PERMIT MODIFICATION APPROVAL

Re: Permit Modification Approval for API Number 8509987 , Well #: LEFT FORK UNIT #3H extended lateral

Antero Resources Appalachian Corporation (Antero) would like to submit the following permit modifications for three approved wells on the Lockhart Heirs West Pad. We are requesting to extend the horizontal lateral which will change the bottom hole locations of the Left Fork Unit 1H (API# 47-085-09985), Left Fork Unit 2H (API# 47-085-09986) and Left Fork Unit 3H (API# 47-085-09987).

Antero Resources Corporation APPALACHIAN BASIN Left Fork Unit 3H Ritchie County 2000 4,000 FEET REMARKS QUADRANGLE: PULLMAN WATERSHED: LEFT FORK DISTRICT: UNION 10/11/2013 Date: 7/05/2012

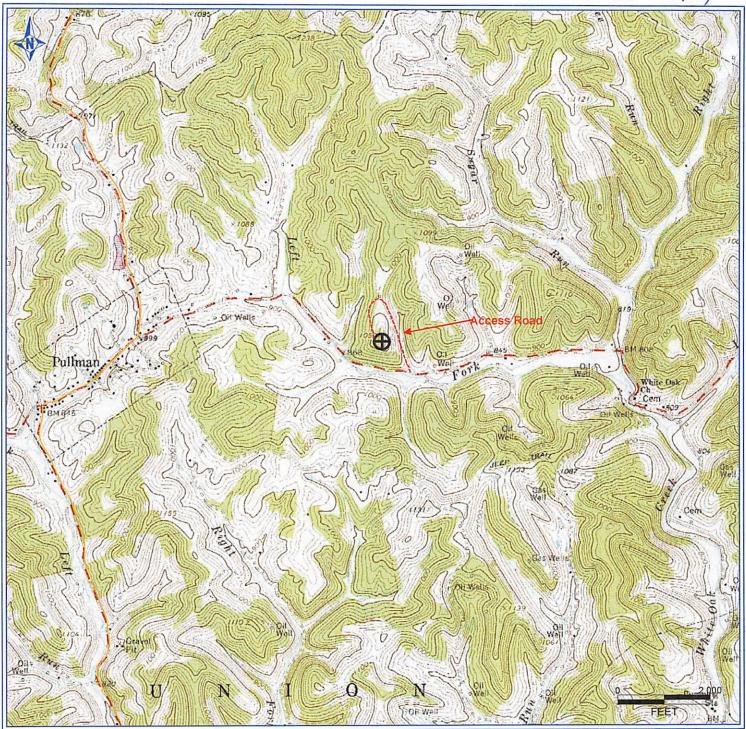
- > REVISED Forms WW-6B, which show the revised MDs and Production Casing/Cement programs
- > REVISED Forms WW-6A1, which show the additional leases we will be drilling into
- > REVISED Mylar Plats, which show the new bottom hole locations
